9.0 PEER REVIEW

This chapter describes the regulatory basis for the conduct of peer reviews and summarizes relevant peer reviews that have been performed at the Waste Isolation Pilot Plant (WIPP). Key elements of the U.S. Department of Energy (DOE) Carlsbad Area Office (CAO) peer review program (for example, the review process, reports, and selection criteria and training for review panel members) are discussed. Three categories of peer reviews are reported in this chapter: (1) those conducted after the promulgation of Title 40 of the Code of Federal Regulations (CFR) Part 194 (U.S. Environmental Protection Agency [EPA] 1996a); (2) those conducted earlier; and (3) future or ongoing peer reviews.

Figure 9-1. Cumulative Brine Flow through the Panel Closure between the Intruded Panel and the Rest of the Repository for Permeabilities of 10^{-15} to 10^{-17} m^2

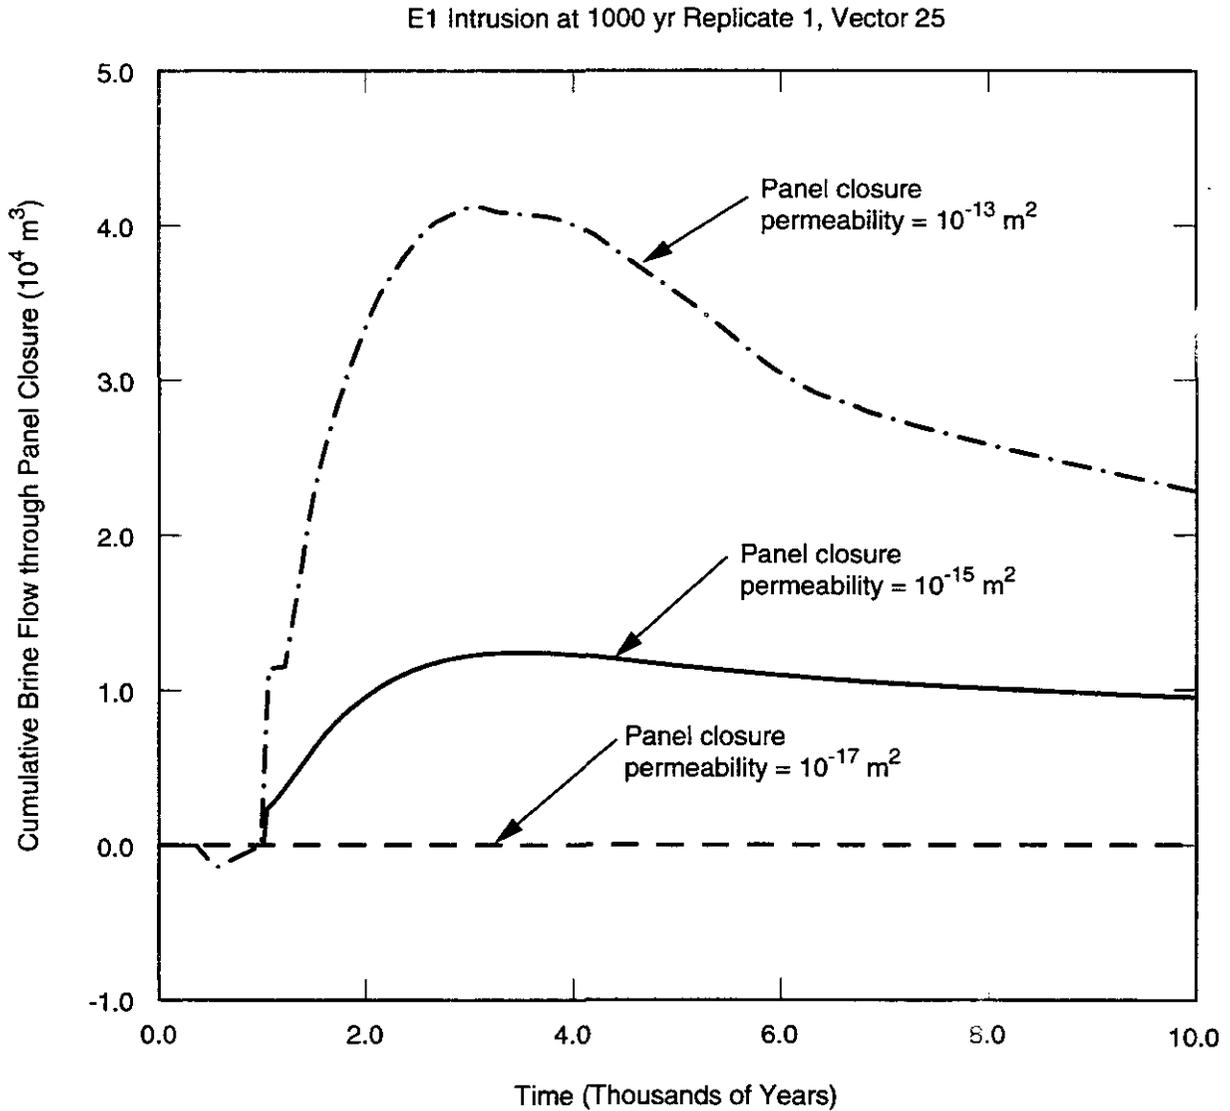
11
12 *The long-term performance of the panel closure seals has not been subjected to a*
13 *detailed engineering evaluation of the type performed for the shaft seal. The role of*
14 *the panel seals in restricting brine flow among the waste panels and into other parts*
15 *of the repository is an important element of the conceptual model and its*
16 *implementation in performance assessment.*

19
20 The panel is concerned about the lack of supporting evaluations presented to them for the
21 panel seal permeability assumption of 10^{-15} square meters.

30
31 **Response for panel seals:** Because of the high permeability within the panel seals (10^{-15}
32 square meters) the long-term flow should not be sensitive to variants in the seal permeability.
33 The permeability of the panels is set to the same value as the surrounding DRZ. If the panel
34 seal permeability is tighter, then flow between the waste regions will be diverted from the
35 seals through the lower permeability DRZ. The resulting communication between waste
36 regions should be similar. The flow via the panel seals is quantified by considering the
37 compliance certification application run with the highest flow through the panel seal between
38 the intruded panel and the rest of the repository. This was run R1_S3_V25 (replicate 1,
39 scenario 3 (E1 intrusion at 1,000 years), run or vector 25). This run was repeated with a panel
40 seal permeability of 10^{-17} square meters. Figure 9-1 shows a maximum cumulative brine flux

24
25 The long-term panel seal response has now been evaluated, and is documented in a 1996
26 memorandum by Thompson and Hansen (a complete copy of the Thompson and Hansen
27 memorandum is provided in Appendix PEER, Section PEER.2). Basically, this memorandum
28 argues that:

Figure 9-2. Actinide Transport to the Magenta, E1 Intrusion

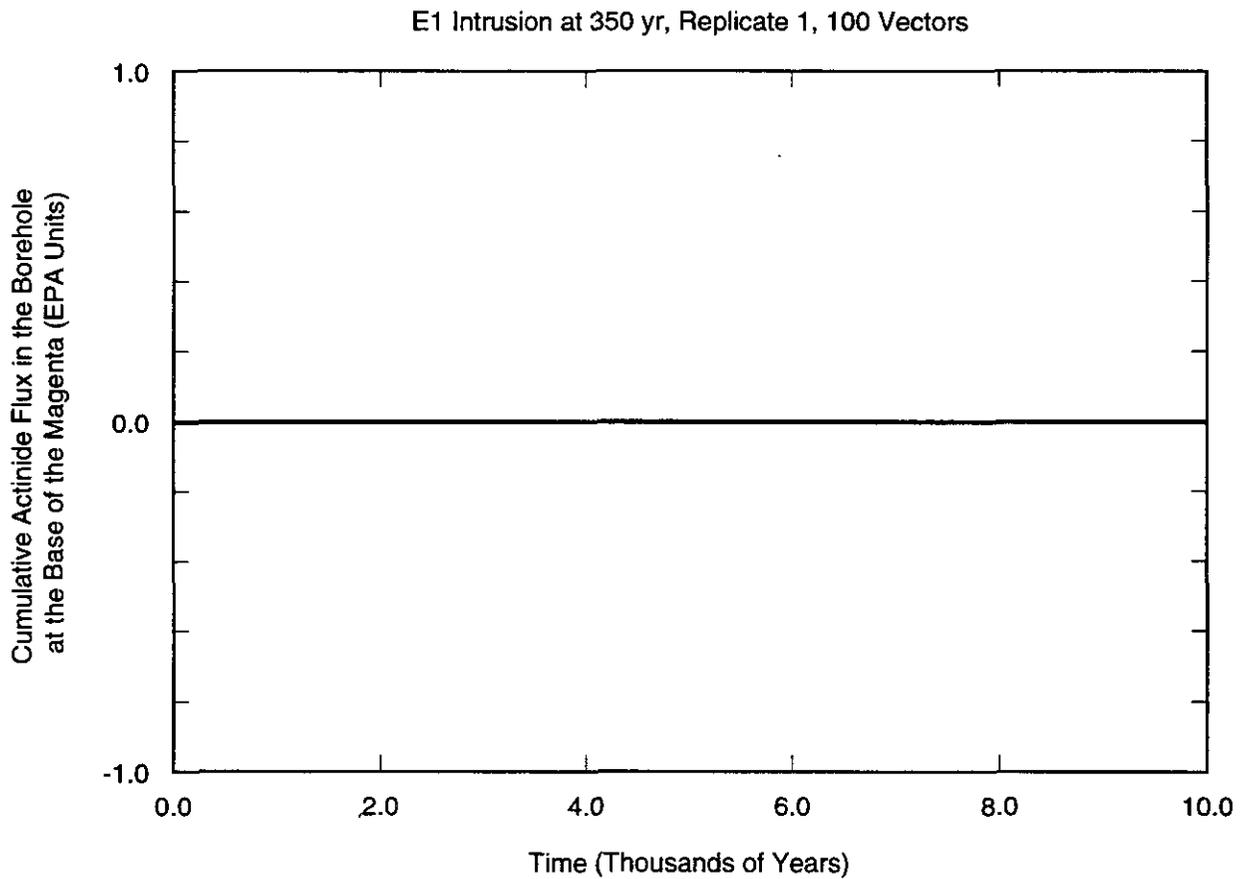
24
25 The DOE understood the issues; however, the panel concluded that the response did not
26 reasonably address its concerns. The panel noted, however, that the inadequacy of the model
27 is of no consequence to the performance assessment.

15
16 The nonexistence of nuclide transport above the Culebra was demonstrated by the
17 performance assessment simulations. Figure 9-2 shows the cumulative nuclide flux (in EPA
18 units) up the borehole at a location above the Culebra and immediately below the Magenta.
19 The figure includes all 100 NUTS runs from the first replicate of the E1 scenario. The E1
20 scenario is expected to have the highest borehole releases. This figure shows that the
21 transport above the Culebra is zero uniformly over all 100 vectors

Figure 9-4. Cumulative Brine Flow through the Panel Closure between the Intruded Panel and the Rest of the Repository

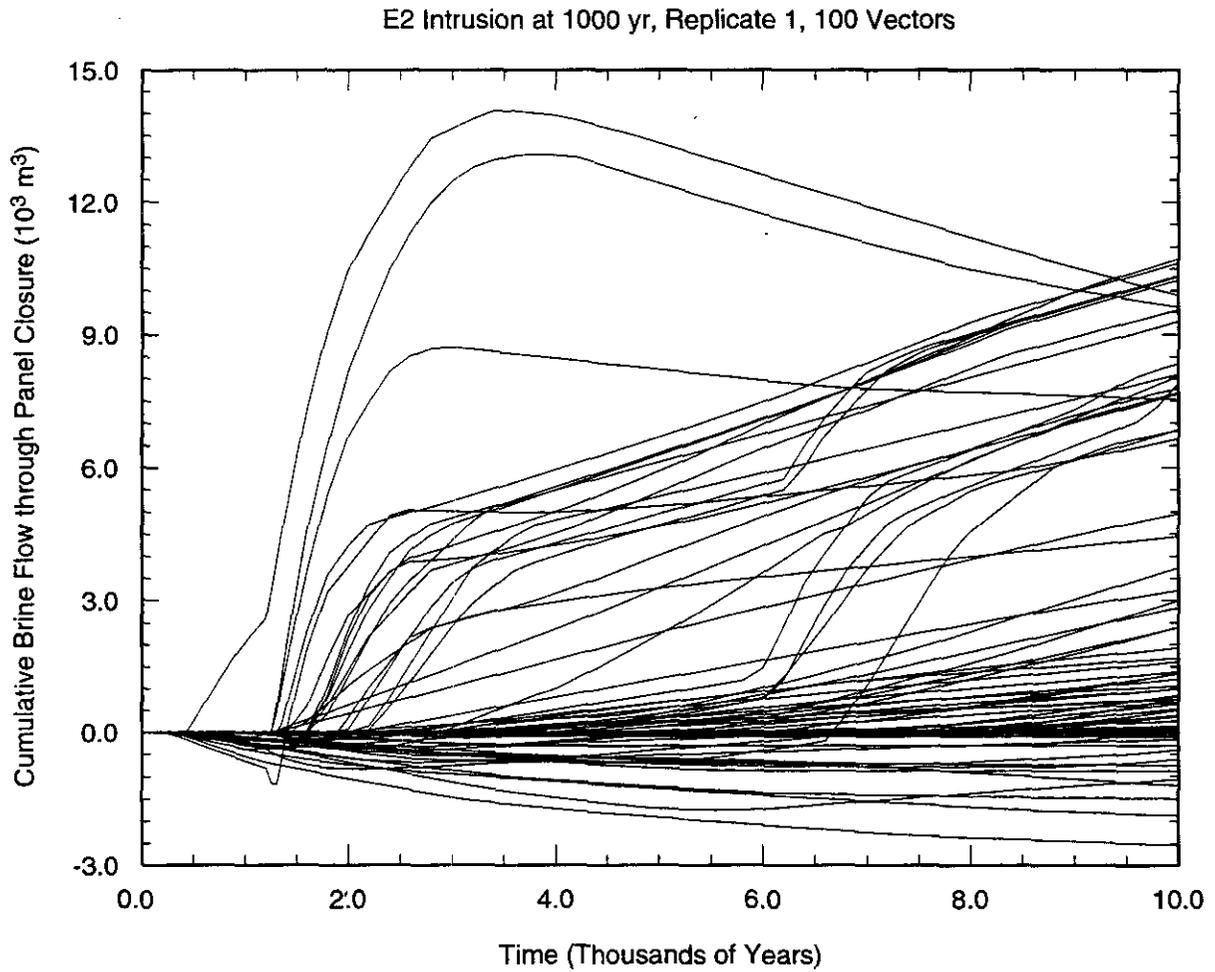
15
16 *Long-term releases from an E2 intrusion in the experimental and operations regions.*

17 Figure 9-4 shows the net brine flow through the panel closure separating the southern, down-
18 dip panel from the rest of the repository following an E2 intrusion at 1,000 years (100
19 realizations, replicate 1). Two types of behavior can be observed. In most realizations, net
20 flow is away from the borehole, as in the E1 scenario. For these realizations, an E2 borehole
21 in the northern region would not provide a pathway for radionuclide transport to the accessible
22 environment. In other realizations, net flow following intrusion is toward the borehole, and
23 with flow volumes ranging from zero to less than 3,000 cubic meters. E2 boreholes in the
24 southern portion of the operations region, where they are separated from the nearest waste by
25 only a single set of panel closures, do have the potential to provide a pathway for radionuclide
26 release if they display this type of behavior. As can be seen in Figure 3-2, this southern

Figure 9-5. Sketch Showing Necessary Flow Path for Castile Brine To Carry Contaminants from Intruded Panel to Surface

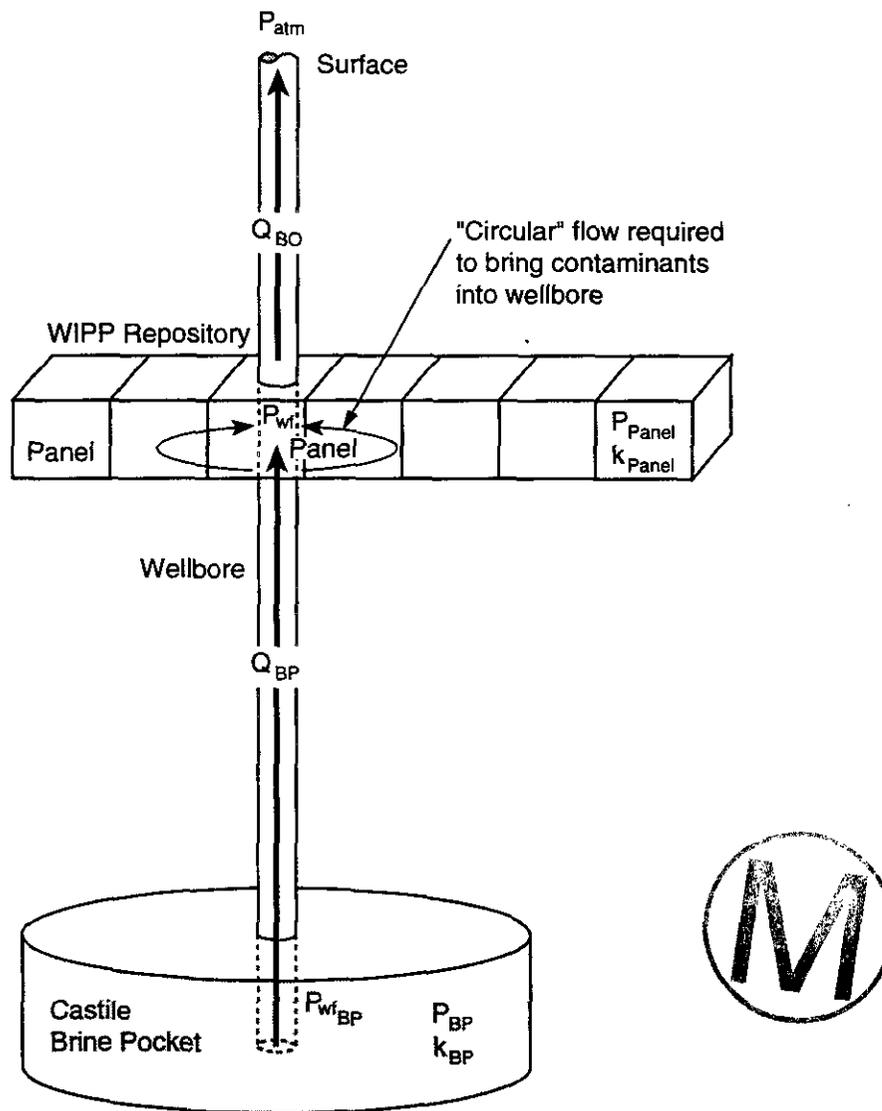
10
11 *The possibility that an effect on the repository could result from Castile brine*
12 *encountered in an E1 borehole that is assigned a three-plug configuration does not*
13 *appear to have been considered in the conceptual model. Castile brine could enter the*
14 *repository during drilling before the borehole is cased and result in increased rates of*
15 *corrosion, waste degradation, and gas production.*

16
17 Statement of Issues (Note: For the purpose of this response, the above exploration borehole
18 concern has been combined with the first direct brine release concern regarding the transport
19 of radionuclides with the discharge of brine [see Section 9.3.1.2.8.1].)

31
32 Figure 9-5 illustrates the problem. The drill bit first passes through the waste panel, at which
33 time one of two events may occur: the wellbore experiences a “blowout”, or brine flow from
34 the panel into the wellbore (resulting in releases to the surface), or the well experiences “lost
35 circulation”, in which the drilling mud flows out of the wellbore and into the panel. The first
36 event requires that the pressure differential be toward the wellbore (that is, $P_{\text{panel}} > P_{\text{wf Panel}}$).
37 $P_{\text{wf Panel}}$ is the initial flowing wellbore pressure at the drill bit, which is equivalent to the
38 pressure exerted by the column of drilling mud from the surface to the WIPP horizon. Current
39 drillers in the area use a 1.23 specific-gravity-brine saturated mud, which will exert a pressure
40 of approximately 8×10^6 pascals at the repository. When this pressure is exceeded in the

41 panel, direct releases are accounted for in the Spall model for solids (within the
42 CUTTINGS_S code), and the direct brine release model for dissolved radionuclides (Q_{BO} in
43 Figure 9-5).

Figure 9-24. Phase Diagram for the MgO - CO₂ System

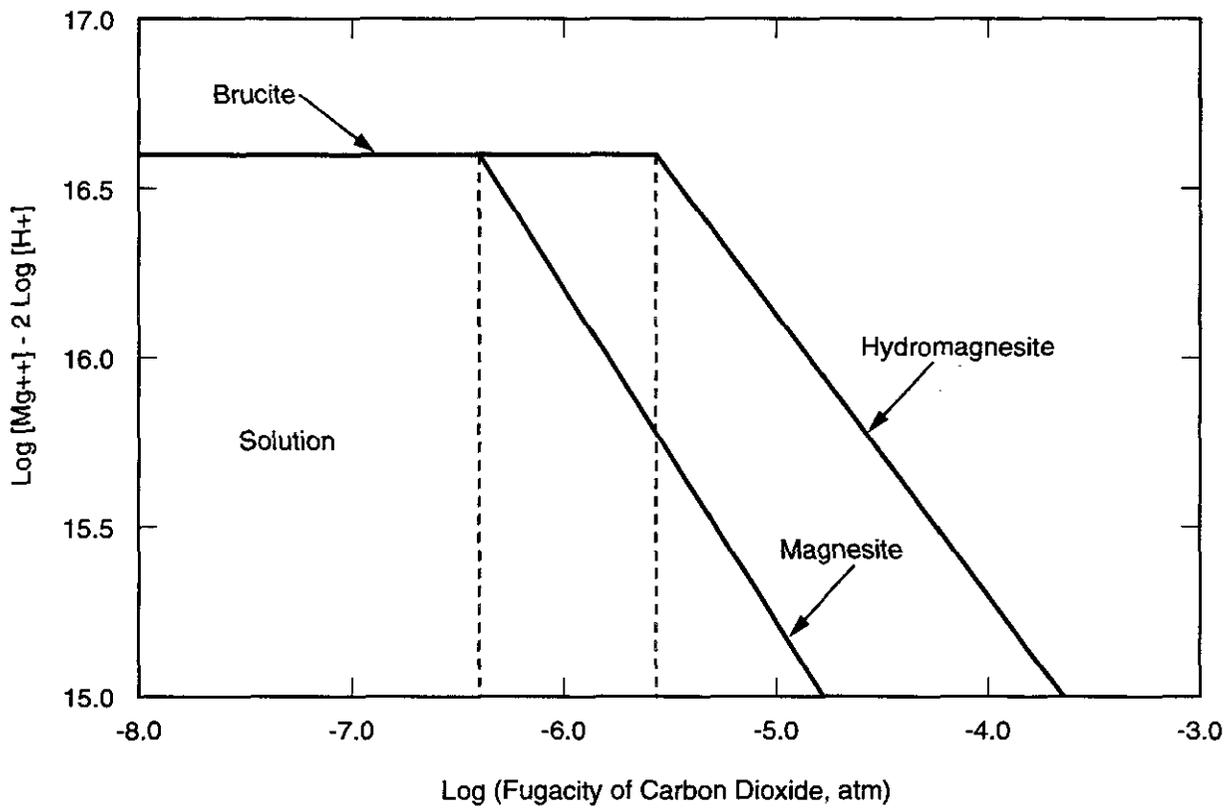
23
24 The panel understands that in theory MgO (periclase) and Mg(OH)₂ (brucite) react with CO₂
25 to create carbonate phases such as MgCO₃ (magnesite). The carbonate equilibria impose a pH
26 control on the brines resident in the waste panels. The panel questions whether or not the
27 buffering phases will form fast enough that no excess CO₂ will remain. In addition, the panel
28 recognizes that equilibrium thermodynamic codes have performed calculations of the phases
29 and compositions that will be stable in the WIPP repository. The panel questions whether or
30 not the codes were sufficiently complete to account for all possible Mg-containing carbonate
31 phases that might occur either through absolute stability or metastable stability. The panel's
32 concern is that the actual phase assemblage may impose geochemical conditions that differ
33 from those calculated, and that the actual conditions might result in different solubilities and

25
26 In the MgO backfilled WIPP system, there will always be a brucite phase formed due to the
27 large excess of MgO being added to the system. This brucite phase establishes one dimension
28 of the phase diagram for the system as shown in Figure 9-24. The formation of magnesite in
29 the repository will yield the conditions as shown at the intersection of the brucite and
30 magnesite lines, corresponding to a log $f\text{CO}_2$ of approximately -6.4. If the formation of
31 magnesite does not occur, as simulated by its suppression, the conditions in the repository will
32 correspond to those along the brucite line where it intersects with the next magnesium
33 carbonate containing phase, in this case hydromagnesite, yielding a log $f\text{CO}_2$ of approximately
34 -5.6. This small difference in $f\text{CO}_2$, if indeed it occurs, is not sufficient to cause significant
35 changes in the actinide solubility.

10
11 Figure 9-24 (see Section 9.3.1.2.10.2) presents an abbreviated phase diagram for the system.
12 This phase diagram is abbreviated in that calcium containing phases are omitted since (1) the
13 formation of dolomite is not kinetically favorable, and (2) the conditions will be dominated by
14 the magnesium chemistry due to its extreme excess and the rapid consumption of any
15 $\text{Ca}(\text{OH})_2$ by relatively small quantities of CO_2 which may be generated. This phase diagram
16 shows that under the worst case, hydromagnesite will form yielding an $f\text{CO}_2$ of approximately
17 an order of magnitude greater than that found when magnesite is allowed to form. This
18 possible increase of carbon dioxide fugacity is not sufficient to cause a significant increase in
19 the actinide solubility.

Figure 9-27. Permeability versus Fractional Density for WIPP Crushed Salt

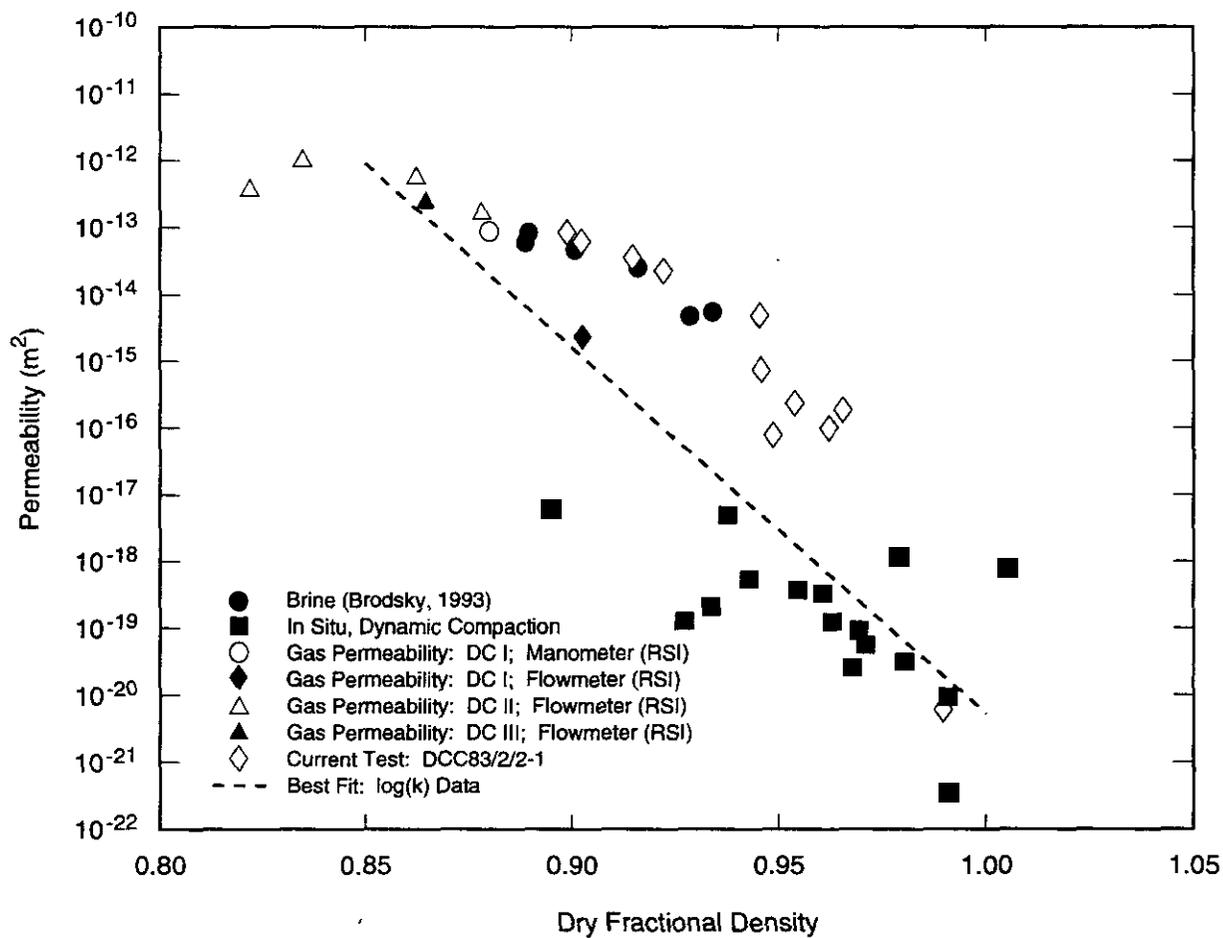
15
16 *Based on current data, the Form 464 values may be too low, but new data being*
17 *analyzed by SNL may establish the validity of these values or lead to a modification of*
18 *them. The panel was unable to form a conclusion until this analysis is completed.*

21
22 The ESPR panel has suggested that the permeability versus fractional density data be
23 reviewed, and consideration given to development of two trend lines as a means to interpret
24 the permeability versus fractional density of the compacted crushed salt shaft seal component,
25 and that more data and analysis is necessary in order to justify the interpretation taken in
26 development of the PDFs.

29
30 The PDF (best estimate and upper and lower bounds) on the Form 464 for the permeability of
31 crushed salt is appropriate, because the range of values incorporated into the PDF take into
32 account virtually all of the data obtained, and any reasonable extrapolation thereof. To justify
33 this point, first an explanation will be given as to why the interpretation of the permeability
34 versus density function, given in Figure 9-27, was selected as opposed to the interpretation
35 suggested as a possibility by the peer review panel, given in Figure 9-28. Then, further
36 justification will be given for the selection of the interpretation given in Figure 9-27.

40
41 In conclusion, it is the DOE's position that the PDF given in Form 464 for the permeability of
42 crushed salt is a good approximation. The permeability versus density function given in
43 Figure 9-27, and used in the development of the PDF for the permeability of crushed salt
44 represent the best possible interpretation of existing data. The development of this function
